STAFF REPORT
COMMUNITY DEVELOPMENT DEPARTMENT

HEARING DATE: 2/18/2025
TO: Mayor & City Council
FROM: Sonya Allen, Associate Planner
208-884-5533
SUBJECT: Tanner Creek No. 1
FP-2024-0025
LOCATION: 615 W. Waltman Ln., in the SE Quarter
of Section 13, T.3N., R.1W.

Final plat consisting of 52 buildable lots and nine (9) common lots on 11.73-acres of land in the R-8 and R-15 zoning districts. This is the first phase of Tanner Creek Subdivision.

JOB NO. 23-64
SHEET 1 OF 3

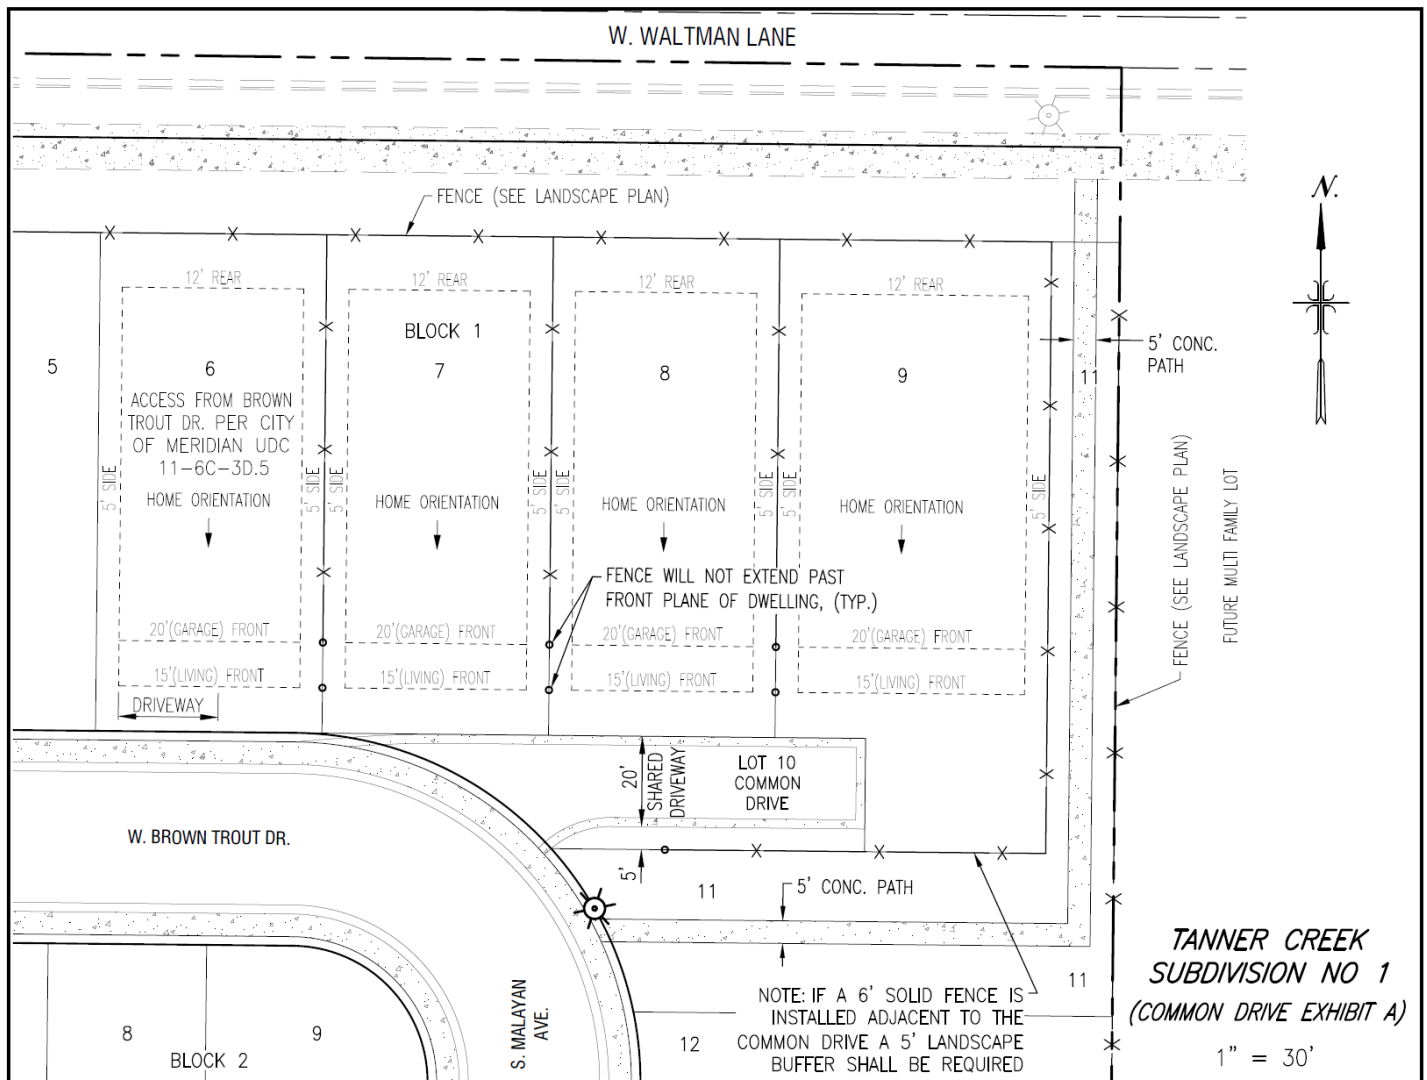
- a. Lot 6, Block 5 needs to be revised to meeting the minimum lot size of 4,000 square feet.
 - b. Depict an ingress-egress easement across Lot 1, Block 5 to the outparcel at the northwest corner of the site (i.e. Martinez property #S1213428080) in alignment with W. Brown Trout Dr. for future access.

- c. Include the recorded easement number for the City of Meridian sewer and water easement graphically depicted on Sheet 1.
 - d. Include the recorded instrument number for the access easement graphically depicted on Sheet 1.

- e. Include the recorded instrument number for the ACHD easement line noted in the Legend.
 - f. Note #10: Include the recorded instrument number of the development agreement (i.e. #2024-007677).

- g. Note #12: Include the recorded instrument number of the ACHD temporary license agreement.
 - h. Note #15: The note shall include a requirement for maintenance of a paved surface capable of supporting fire vehicles and equipment per UDC 11-6C-3D.8. Change "blanket cross access" to "perpetual ingress egress" easement.
